Sheet: /Sensor_Circuits/

Title: ECE445M Sensor Board

Rev: v8.0.2

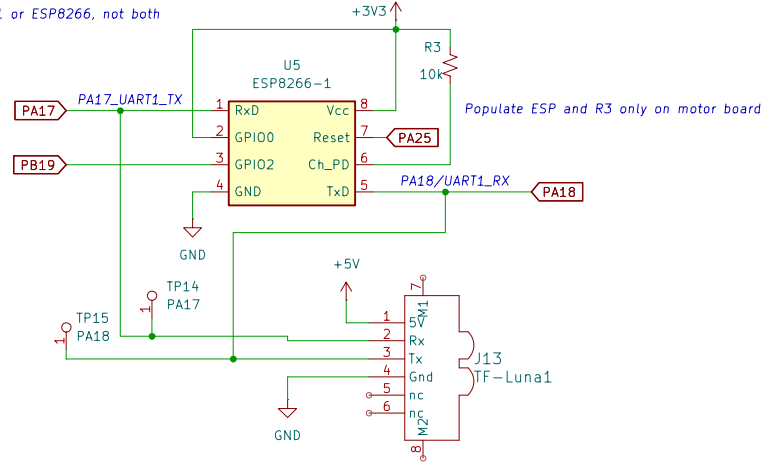
Bug in Version 7, connect pin 5 to 3.3V with 0.1uF cap
TCAN1057A-Q1 (pin 5 nc)
TCAN1057AVDRQ1 (pin 5 to 3.3V)
